IREDELL COUNTY HEALTH DEPARTMENT

IMPROVEMENT PERMIT / CERTIFICATE OF COMPLETION / OPERATION PERMIT / EXISTING SYSTEM INSPECTION

LOCATION ON NORTH SIDE OF FAITH ROAD 6/10 MILE EAST OF HWY 115 SOUTH OF MOORESVILLE, CUL DE SAC LOT, HARDWICK RD.

SUBDIVISION SERENE LAKE BLOCK / SECTION _____ LOT 20 LOT AREA 20,000 SITE CLASS. P L.T.A.R. 0.25 - 0.3

INITIAL SITE SKETCH

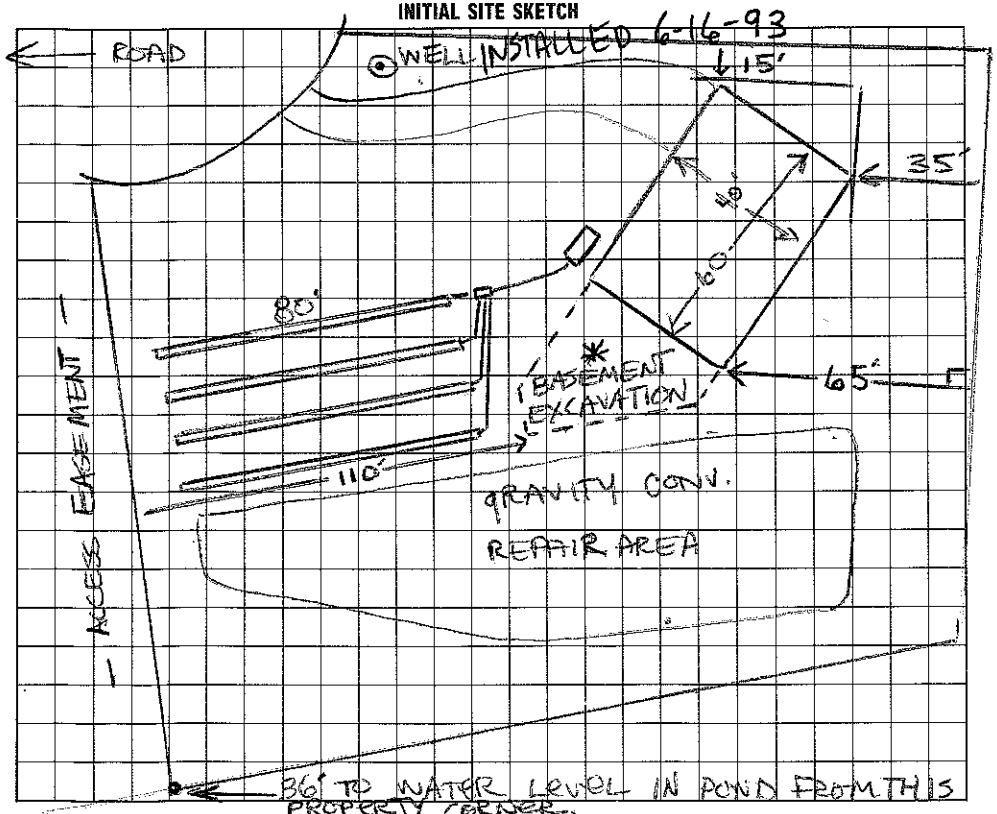
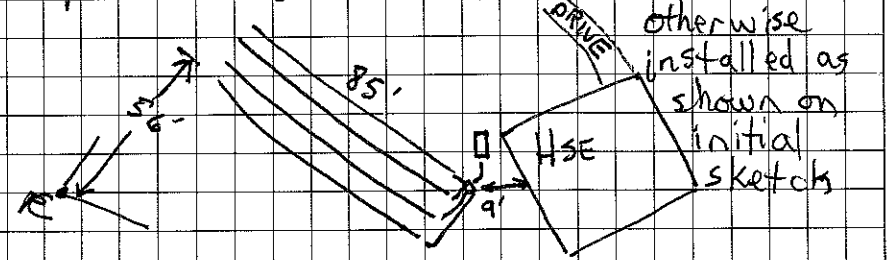
Comments *BASEMENT EXCAVATION CANNOT EXTEND INTO DRAINFIELD ~~AREA~~ OR WITHIN 15' OF IT. EXCAVATION SPOILS CANNOT ~~BE~~ SPREAD OVER DRAINFIELD AREA. DO NOT INSTALL DURING WET SOIL CONDITIONS OR RAIN. 2-4" OF LOAMY TOPSOIL MAY BE SPREAD OVER DRAINFIELD AFTER INSTALLATION - SEW WITH GRASS COVER CROP TO PREVENT EROSION.

10-14-93 change in house location - downhill 12' so that sideline setback will be 27'. back line setback will remain 35' - Do not bring house forward. Plumbing stubout must be near the left end of the house to meet the tank location. Tank and system location and system design is not changed. Basement excavation cannot extend into repair area. Andrea Lemon

otherwise installed as shown on initial sketch
